**DEPARTMENT OF TRANSPORTATION****National Highway Traffic Safety Administration****49 CFR Parts 571 and 585****[Docket No. NHTSA–2007–27986]****RIN 2127–AJ96****Federal Motor Vehicle Safety Standards; Head Restraints****AGENCY:** National Highway Traffic Safety Administration (NHTSA), DOT.**ACTION:** Final rule; response to petitions for reconsideration.

**SUMMARY:** This document completes the agency's response to petitions for reconsideration of the December 2004 final rule upgrading our head restraints standard. We are partially granting and partially denying the petitions.

**Figure 1. Risk of Whiplash Injury versus Head to Torso Rotation on the Hybrid III 50<sup>th</sup> percentile male dummy**

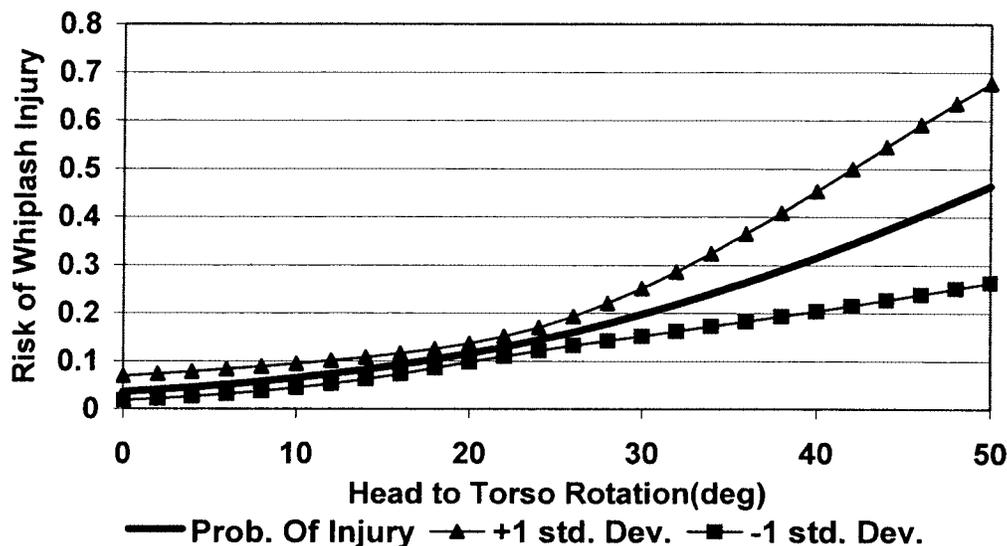
Unfortunately, the agency incorrectly presented in the final rule preamble a graph of head displacement rather than

head rotation (69 FR at 74874). The graph should have been the following:

This correct graph addresses some of the questions raised by the petitioners.

Figure 4 of §571.202a – Portion of gap above 540 mm height.

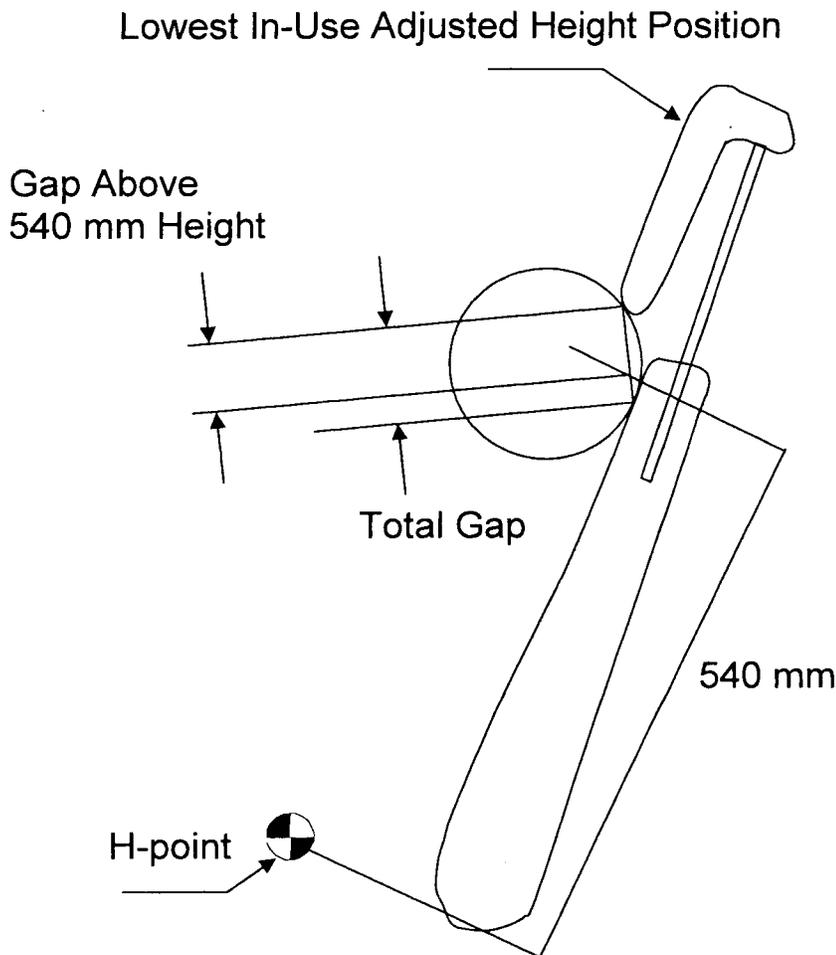
Also, we are adding a new Figure 4 that we believe will help clarify the requirement when using the sphere.
